A Review of the Oconee-3 Probabilistic Risk Assessment

External Events, Core Damage Frequency

Brookhaven National Laboratory

NUREG/CR-4374
BNL-NUREG-51917
Vol. 2

Figure 3.11 Comparison of cases 1 and 2.

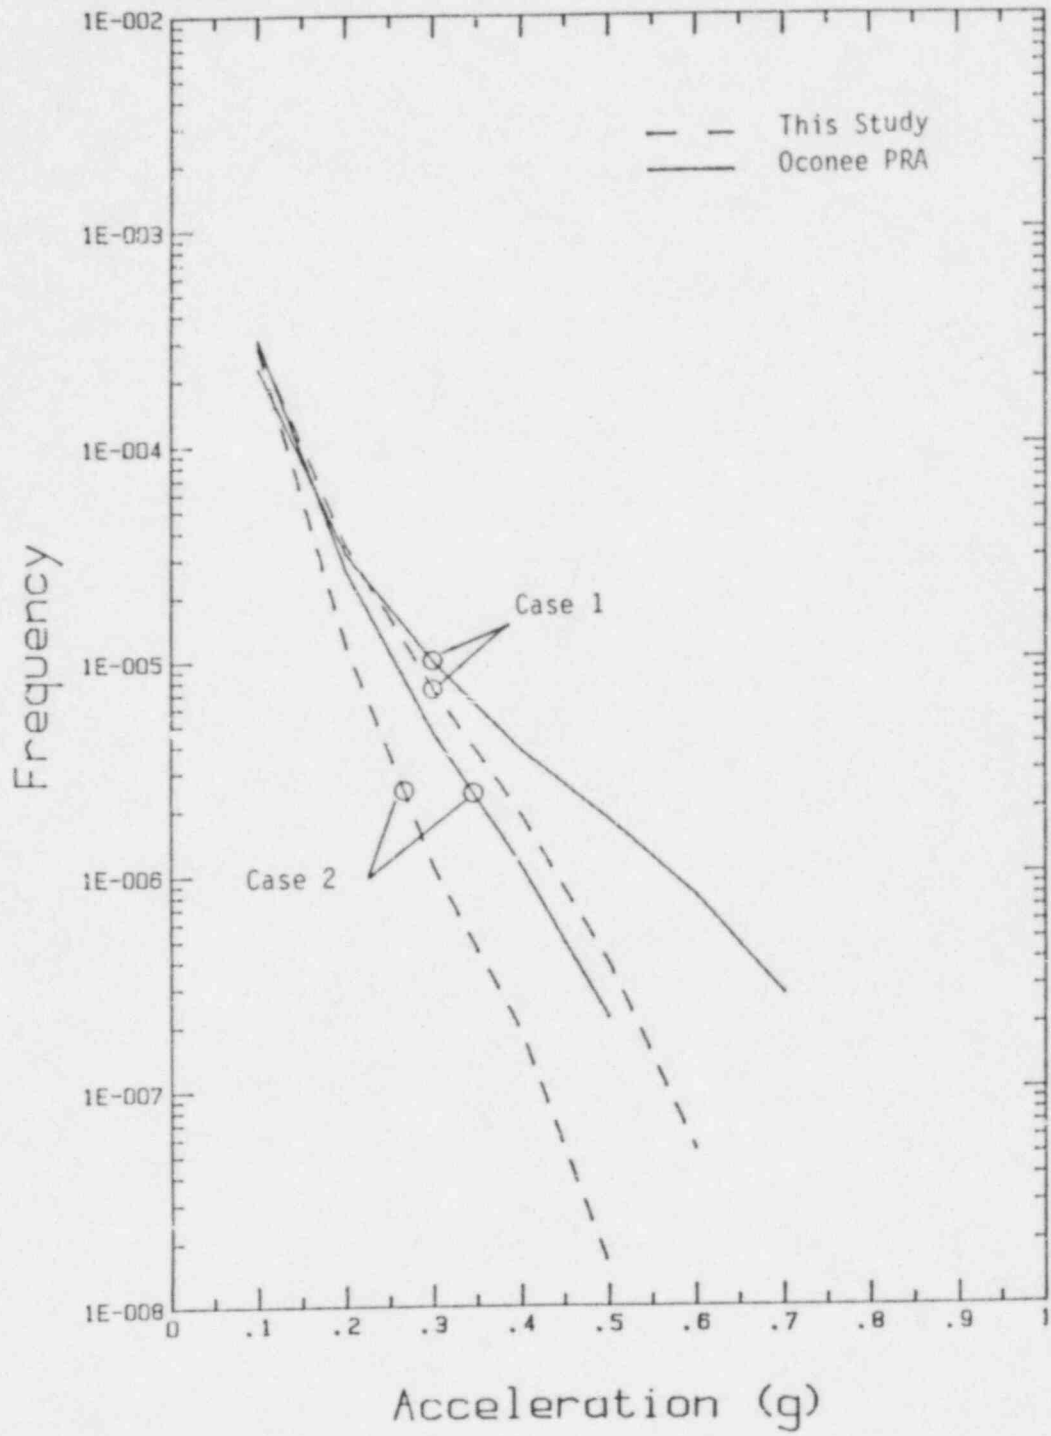
The results of our calculations and those reported in the OPRA are shown in Figure 3.11 in terms of sustained ground acceleration. From the figure it can be seen that beyond 0.40g, there are differences of greater than a factor of 2 between the two estimates for case 1 (i.e., OPRA and this study). For case 2, there is a factor of 2 difference at 0.20g's. Note that the Oconee hazard estimates are higher.

These findings were discussed with the author of the Oconee hazard analysis. In this discussion we first confirmed that the input to our calculations were correct. It is unclear, from the results reported in Figure 3.11 and our discussions with the analysts involved in the Oconee study, exactly what truncation level was used in the Oconee calculations. We understand that possibly a truncation at greater than two standard deviations was used, although this could not be confirmed. Secondly, it was learned that the seismic hazard results reported in Table 3 of the Oconee hazard report are smoothed values. The ill effects of this smoothing, which was greatest near the truncation limit, are apparent in case 1. From the results of our hazard computations, we find that only the Piedmont and Upper Coastal Plain source area contribute to the results for accelerations greater than 0.50g. Therefore, the truncation of the hazard curves is limited by the maximum intensity in this source area (i.e., MMI = VIII). From Table 3.3, the limit on acceleration is 0.681g; therefore, beyond 0.681g the frequency of exceedance should be zero. The Oconee hazard curve at 0.70g has a frequency of exceedance of 2.8E-7, which is incorrect.

To reconcile our calculations with the Oconee results for cases 1 and 2, a three standard deviation truncation level was used. Figure 3.12 shows this comparison. For accelerations <0.70g, the results are reasonably close. Above 0.70g, the results are not as favorable since the truncation level is higher for a three standard deviation cutoff.

Figure 3.13 Comparison of cases 1 and 2 using a five standard deviation truncation.

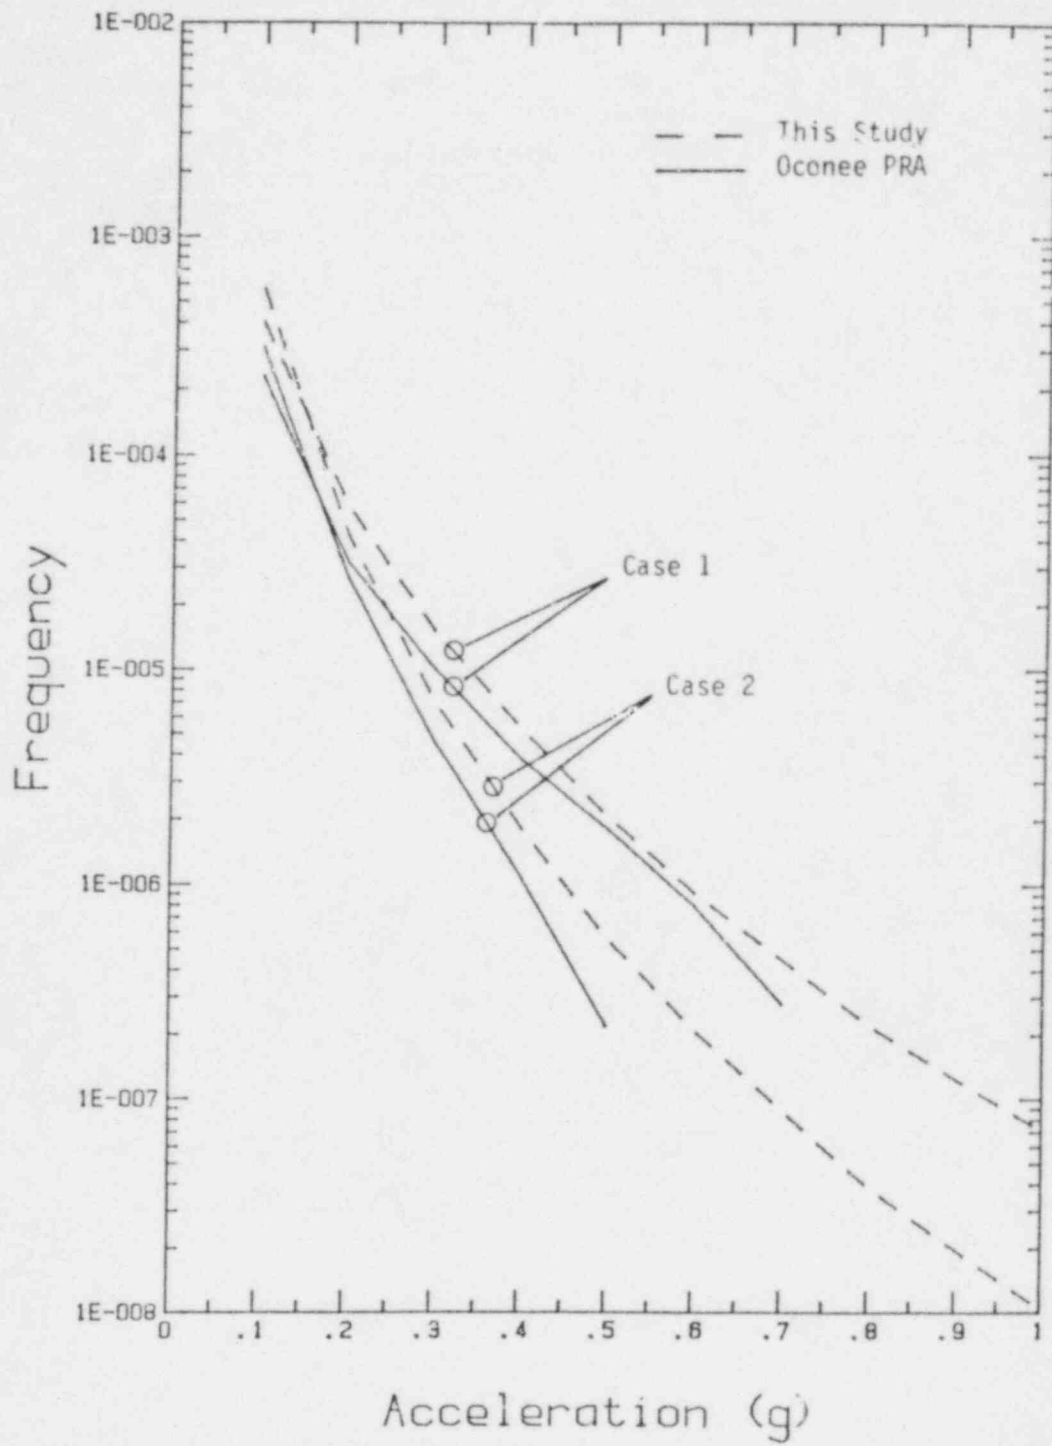
In Figure 3.13, a much higher truncation level of five standard deviations is considered for cases 1 and 2 and are compared to the Oconee results. Using a higher truncation limit produces hazard curves two to three times higher for case 1 and less for case 2. This suggests that for accelerations less than 0.40g, the effect on the hazard results of applying a truncation on acceleration is small.

Figure 3.14 Comparison for cases 1 and 2 hypothesis 1, $I_{\max} = VIII$ for the Piedmont and upper coastal plain source.

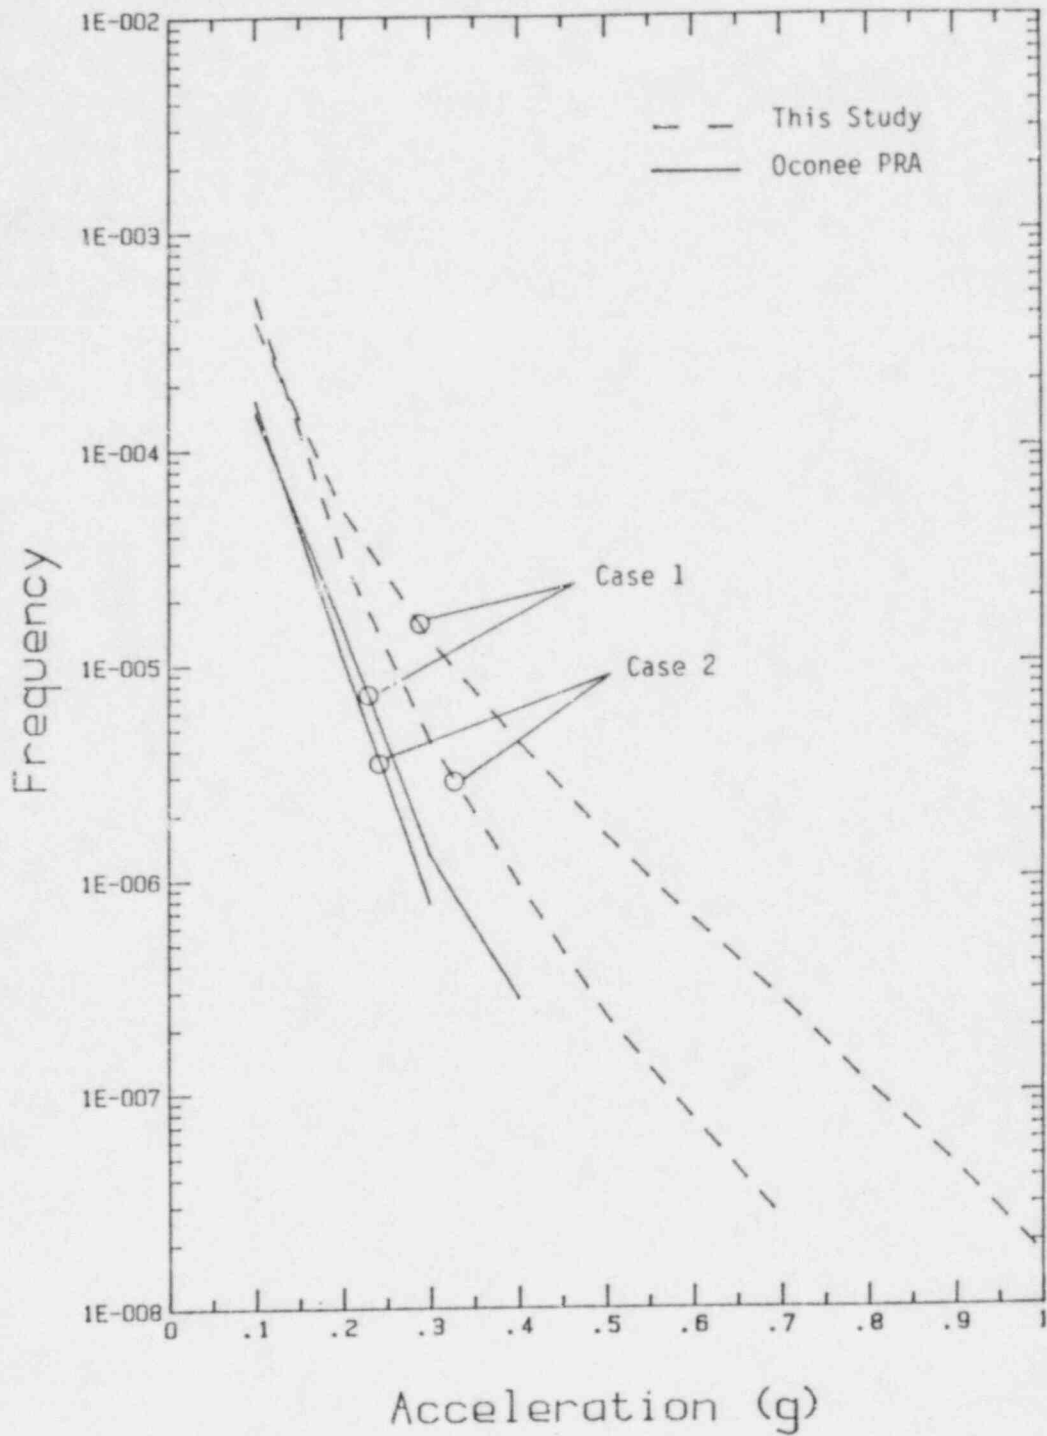
As part of our review, it was stated that the maximum intensity for the Piedmont and Upper Coastal Plain source area for all three hypotheses may be underestimated by one intensity unit. Figures 3.14 to 3.16 compare the effect of increasing the maximum intensity for cases 1 and 2, one unit for each hypothesis on the maximum size earthquake. For the Piedmont and Upper Coastal Plain source, the following revised estimates are made:

For accelerations beyond 0.30g, the difference increases to as much as a factor of 10 (see Figure 3.14). The largest differences are realized for hypothesis 1, while for hypotheses 2 and 3 the largest variations are less than a factor of 5.

Figure 3.17 OPRA seismic event tree.

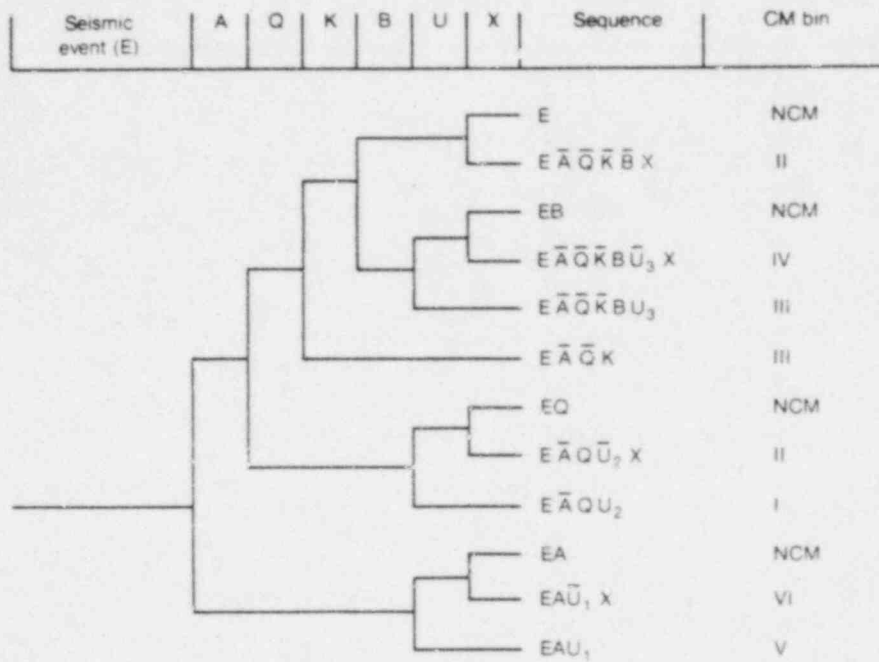
- o Seismic Event Tree: This review is in agreement with the delineation of the seismic event tree presented in the OPRA (Figure 3.17).
- o Supporting Logic and System Fault Trees: As explained in step 1 above, the OPRA eliminated several seismic failure events (see Table 9.5 of the OPRA) for the construction of the supporting logic and systems fault trees. In this review, several of these events were kept in the fault trees (components 38 through 41 in Table 3.5).

Figure 4.1 OPRA cable-shaft fire event tree.

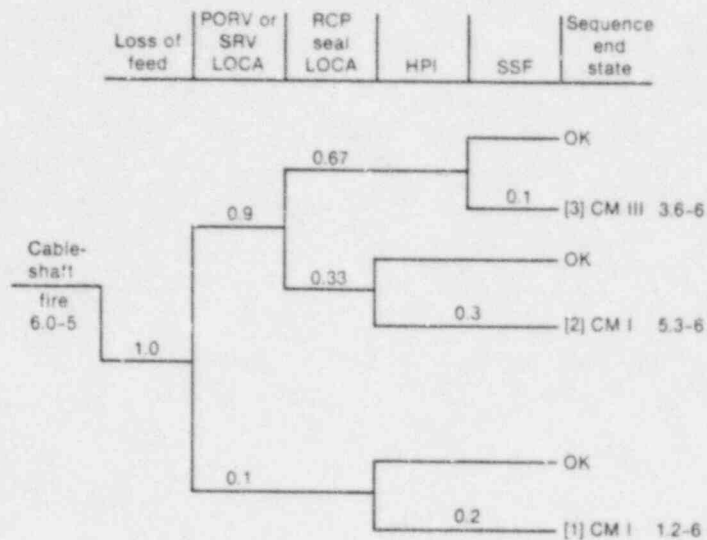
1. BNL is in qualitative agreement with the fire event tree (Figure 4.1).
2. The quantification of the top event HPI, i.e., failure of the operators to indicate HPI, is based on two assumptions:
 - a. The actions to start the HPI function can be remotely performed from the control room.
 - b. The safety injection signal is not generated automatically.

For the above reasons, it is the opinion of the BNL reviewers that the probability of not having the HPIS to mitigate the LOCA (i.e., probability of failure for top event HPI in Figure 4.1) may approach 1.0 if no credit is taken for operator actions to locally open valves 3HP-24 and 3H-25. Note that the OPRA does not indicate that the operators are aware of this problem. To evaluate the failure probability for the top event HPI, a much more detailed analysis would be necessary. Therefore, this review will use the probability equal to 1.0 (i.e., certainty) for the top event HPI as an upper bound, noting that this value may not necessarily be a very conservative assumption.

Figure 4.2 OPRA event tree for sequences initiated by a severe tornado.

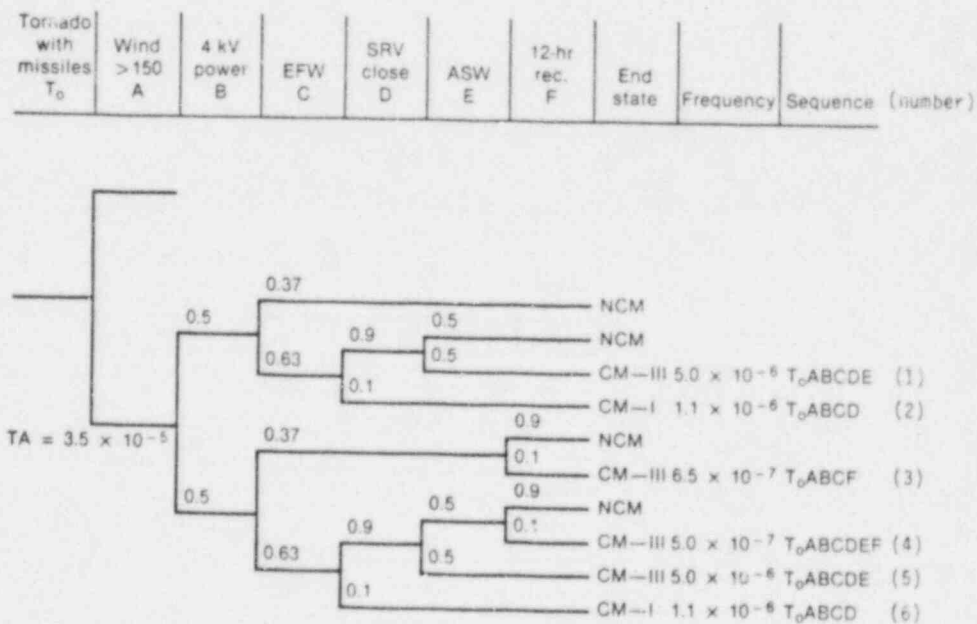
- Using the assumptions above, BNL reviewed the event tree. It is the reviewers' opinion that given a loss of 4-kV power (event B in Figure 4.2), seal leakage will occur (loss of makeup and loss of component cooling). Thermal barrier cooling is lost when component cooling is lost. Additionally, seal injection fails because HPI is not available (loss of 4-kV power and loss of BWST) and because the possibility of makeup from the SSF is also lost as the result of tornado damage to the west penetration room (see OPRA page 9-60, event F). Implications of these failures have been discussed in internal events treatment, where it is shown that core damage will occur in several hours. Note that loss of the BWST means that the seal LOCA cannot be mitigated

even if 4-kV power is restored before core uncover. Therefore, sequences 3 through 6 in Figure 4.2 are substituted by the sequence T₀AB, which is a bin I sequence with a frequency equal to $1.7 \times 10^{-5}/\text{yr}$. The following revised core damage frequencies are then obtained:
